IMPACT FAMILY VILLAGE

MUP - DESIGN REVIEW MEETING Nov 10, 2009

DPD LANDUSE PROJECT # 3009571

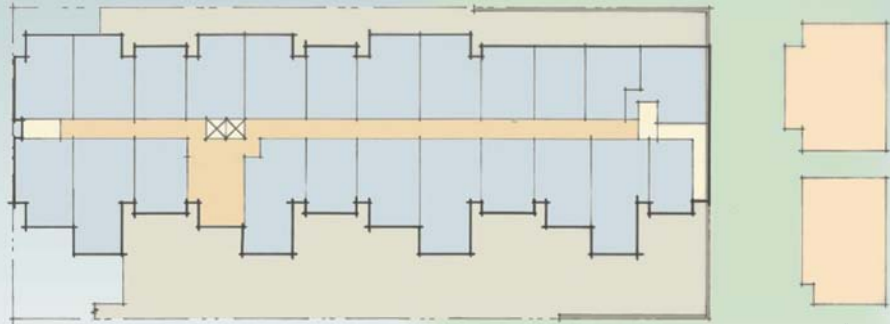
The landscaping plan should tie into the series of proposed retaining walls near the adjacent properties

Ensure adequate screening between the proposal and the adjacent houses to the north and to the east.

Both fences and retaining walls along the north, east, and south property have been planted as vegetative walls, including the exterior wall of the furthest east residential unit. These vegetative walls have been planted facing both the neighbors and facing internally towards the units. Also plants have been planted along those property lines to help soften the edges of the building at the property line both for the neighbors and the residential courtyards. See drawing L101.
